## **Access Compliance Report Public Rights-of-Way** (Curb Ramps)

Intersection ID: 48863 Main Street: STEELE\_CREEK\_RD Cross Street: WALKER\_BRANCH\_DR Location: SW ADA ID: F14CCD8AE0A7 Ramp Type: Perp Initial Pass/Fail: Fail **Overall Compliance: No** Severity Score: 21.25

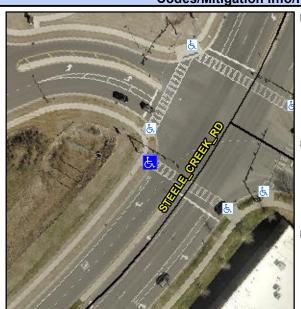
Field Measurements/Component Compliance					
Compliance Description		Data	Comp	oliance Description	Data
N/A	Ramp Length (in)	92.0	No	Ramp Slope (%)	10.1
No	Ramp Width (in)	46.5	Yes	Ramp XSlope (%)	0.6
N/A	Flare Type LT	N/A	N/A	Flare Type RT	N/A
N/A	Flare Slope LT (%)	N/A	N/A	Flare Slope RT (%)	N/A
N/A	Flare Traversable LT?	N/A	N/A	Flare Traversable RT?	N/A
N/A	Landing Length (in)	N/A	N/A	DWS Provided?	N/A
N/A	Landing Width (in)	N/A	N/A	DWS Contrast?	N/A
N/A	Landing Slope (%)	N/A	N/A	DWS Length (in)	N/A
N/A	Landing X Slope (%)	N/A	N/A	DWS Full Width?	N/A
N/A	Landing Curb? (Y/N)	N/A	N/A	DWS Offset (in)	N/A
N/A	Shared Landing?	N/A			
N/A	Gutter Ponding?	N/A	N/A	Gutter Slope (%)	N/A
N/A	Gutter Lip Ht (in)	N/A	N/A	Gutter X Slope (%)	N/A
N/A	Painted X Walk1?	Yes	N/A	Painted X Walk2?	N/A
	X Walk 1 Direction	To SE		X Walk 2 Direction	N/A
N/A	X Walk 1 Width (in)	112.0	N/A	X Walk 2 Width (in)	N/A
	X Walk 1 Slope (%)	8.2		X Walk 2 Slope (%)	N/A

X Walk 1 X Slope (%)	0.7		X Walk 2 X Slope (%)	N/A
N/A	Ramp inside XWalk1?	Yes	N/A	Ramp inside XWalk2?	N/A
	Road Slope (%)	N/A	N/A	Clear Space?	N/A
	Road X Slope (%)	N/A	N/A	Clear Space to XWalk (in)	N/A
N/A	Any Obstructions?	N/A	N/A	Storm Grate/Utility Hazard?	N/A
	Obstruction Type			Storm Grate/Utility Type	
		N/A			N/A
			Yes	Surface Condition? (G/P)	Good

Possible Solutions: Remove & Replace Entire Ramp. Surveyor Notes: N/A PROW/ADA: Not Found, R304.5.1, R304.2.2
